From: Bolt, Matthew [/O=EXCHANGELABS/OU=EXCHANGE ADMINISTRATIVE GROUP (FYDIBOHF23SPDLT)/CN=RECIPIENTS/CN=2456E92CF5334FA5B89AF3DBB9A69119-BOLT, MATTH]
Sent: 3/15/2017 10:07:00 PM
To: Jade Dickens [Dickens.Jade@azdeq.gov]
Subject: FW: Further Queen Creek TMDL draft comments

Table 4: Existing Conditions 24-Hour Average Dissolved Copper Concentrations (µg/L)

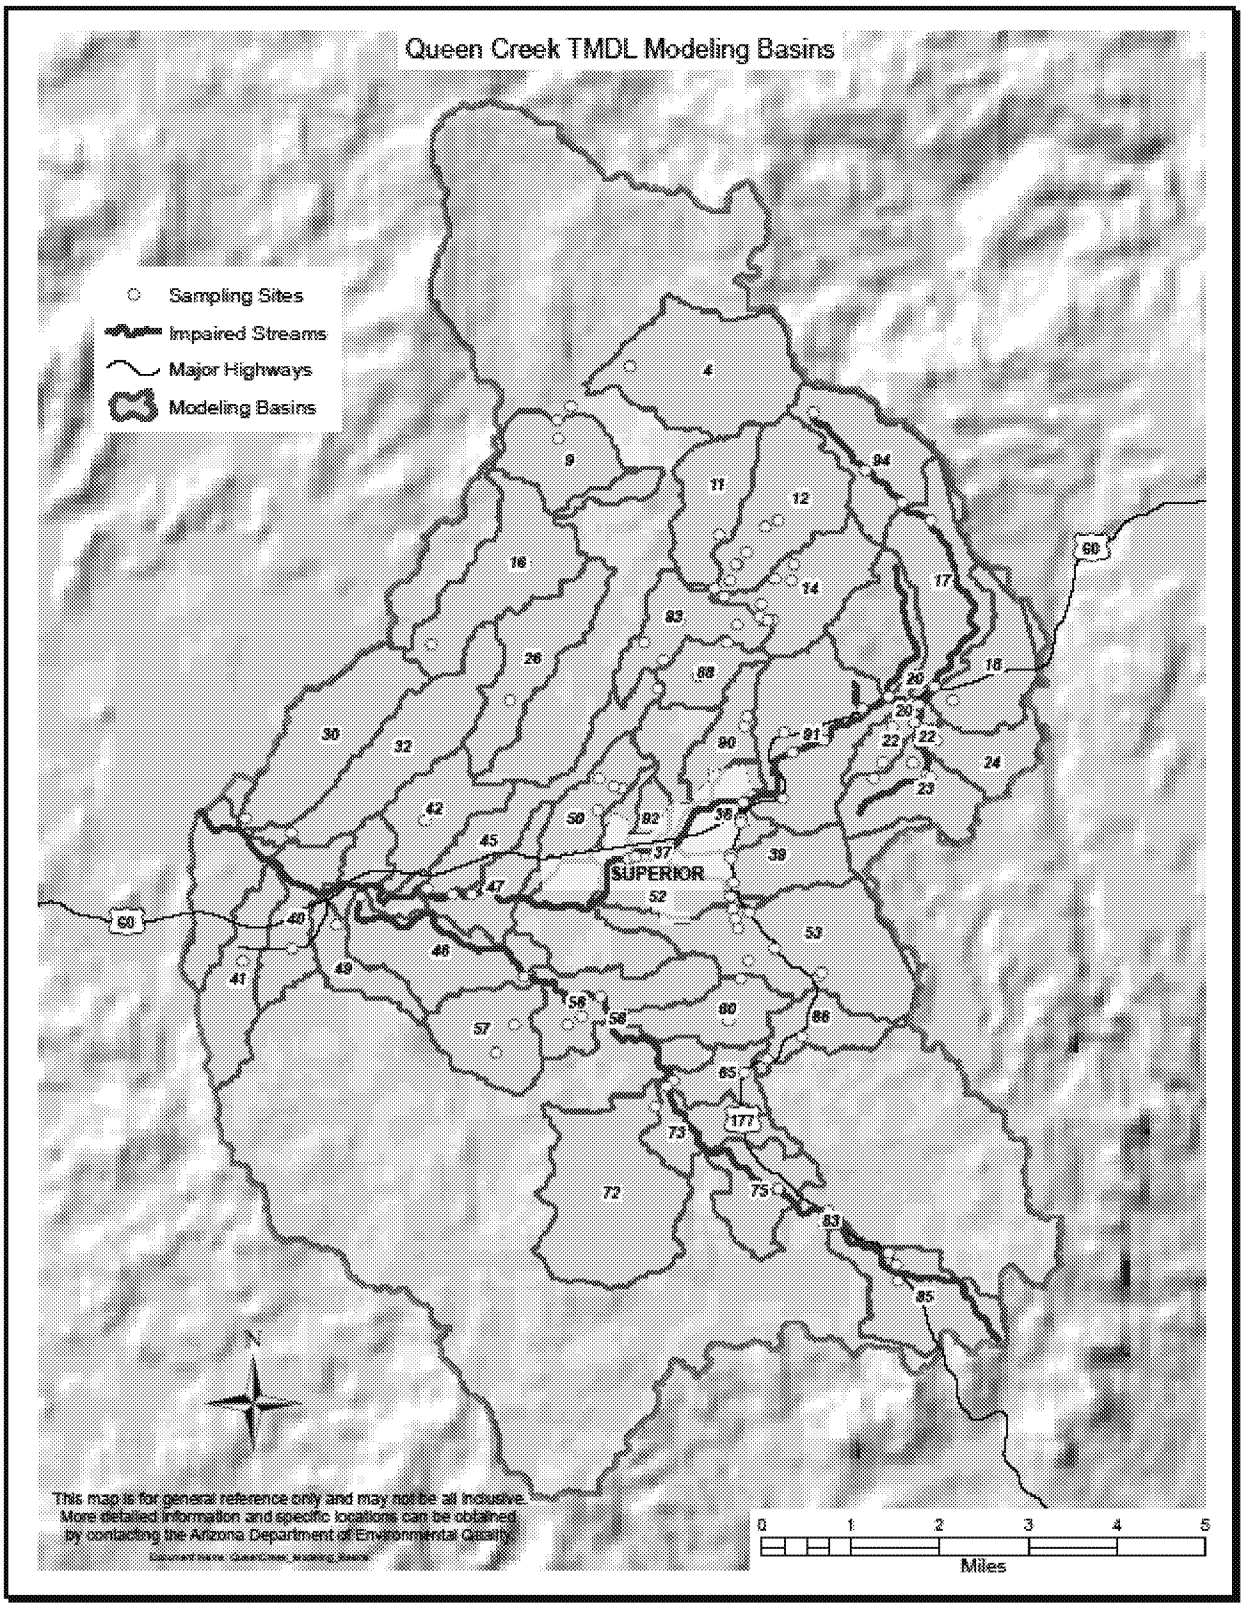
Hi Jade,
Please see the below re: our conversation this afternoon. Just looking at the map and table again, I am having a hard time finding each subbasin and seeing how the average hardness changes from upstream to downstream.
